ERRATA NOTES

CC2550

Figure 1: Window of Uncertainty (drawing not to scale)

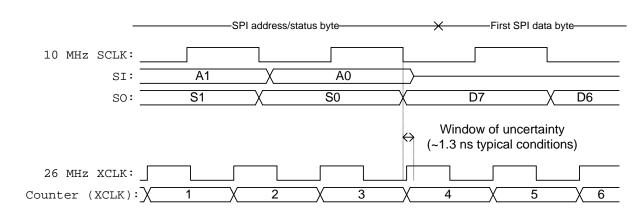
Due to this synchronization issue, if the register being read changes value (synchronously with XCLK) during a certain period of time after this falling edge of SCLK then some of the bits in the read value will come from the previous value and some from the next value. This so-called window of uncertainty is about 1.3 ns for typical conditions and increases to about 2.0 ns for worst-case conditions (1.8 V VDD, 85 °C).

Figure 1 shows a timing diagram of an SPI read that fails when reading a fictitious counter being updated internally each **XCLK**. Since the counter update from value 3 (011b) to 4 (100b) within the window of uncertainty, the read value could be any one of 0-7 (000b, 001b, 010b, 011b, 100b, 101b, 110b, 111b) depending on exactly when the positive edge of **XCLK** falls within the window of uncertainty.

If it is important to **ensure** that read values are not corrupted, reading of one of the affected registers should be done repeatedly until the same value is read twice in succession. If the rate at which the register is read is guaranteed to be at least twice as fast as the expected register update rate, then an upper bound on the number of required reads is four and the average number of reads slightly more than two.
